AMENDMENT OF SOLICITATION/MODIFICATION OF CONTRACT				1. CONTRACT ID CODE	PAGE OF PAGES 1 119
2. AMENDMENT/MODIFICATION NO. 0002		3. EFFECTIVE DATE 19-Jan-2009	4. REQUISITION/PURCHASE REQ. NO.		5. PROJECT NO. (If applicable)

4. DESCRIPTION OF AMENDMENT/MODIFICATION (Organized by UCF section headings, including solicitation/contract subject matter where feasible.)					
a. The purpose of this Amendment is to make changes to the following Sections of the RFP (All revisions are incorporated in this Amendment 0002): (1) SF 1442, Block 13D: No. of calendar days is changed from "300" to "90". (2) Section 00010, Proposal Schedule: Section 00010 is replaced in its entirety. (3) Section 00110, Proposal Preparation: Section 00110 is replaced in its entirety. (4) Section 00800, Clause 52.211-10 Commencement, Prosecution and Completion of Work: No. of calendar days is changed from "180" to "300". (5) Section 01010, Scope of Work - Design Build: Section 01010 is replaced in its entirety. (6) Section 01015, Technical Requirements - Design Build: Section 01015 is replaced in its entirety. (7) Appendix A, Drawings: All Appendix A drawings are replaced with new drawings and are attached to this Ame

1 FLOOR PLAN
A-101 SCALE = 1:200

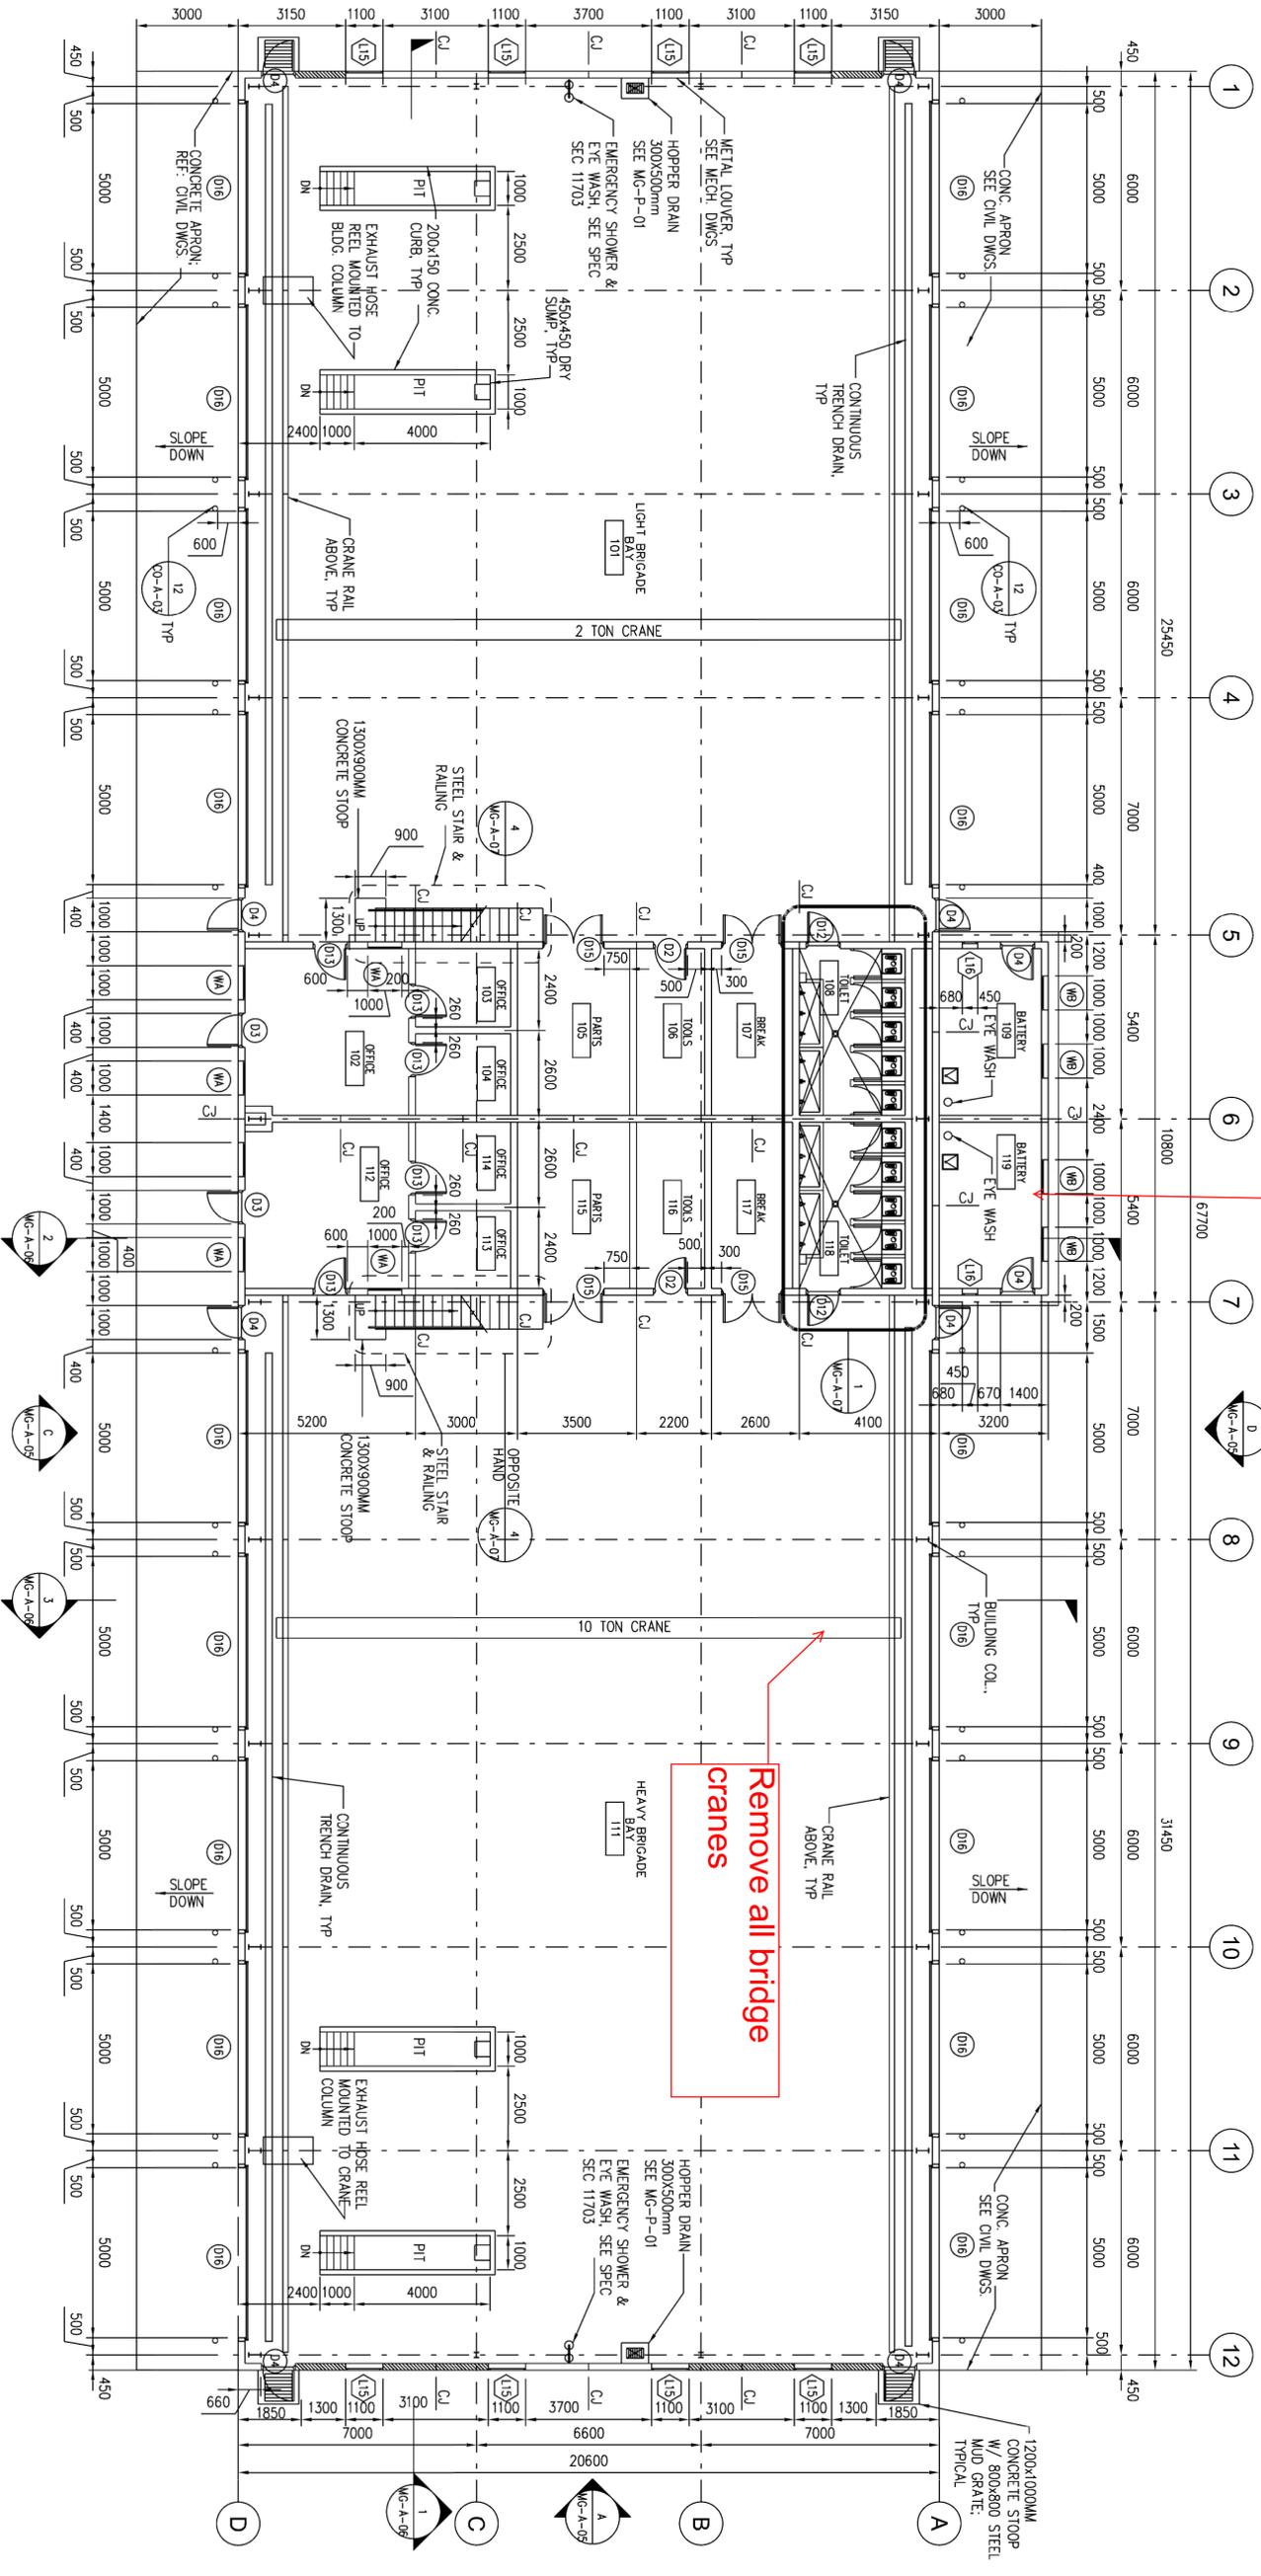
Redesign battery room per drawing of Lead Acid Battery Shop.
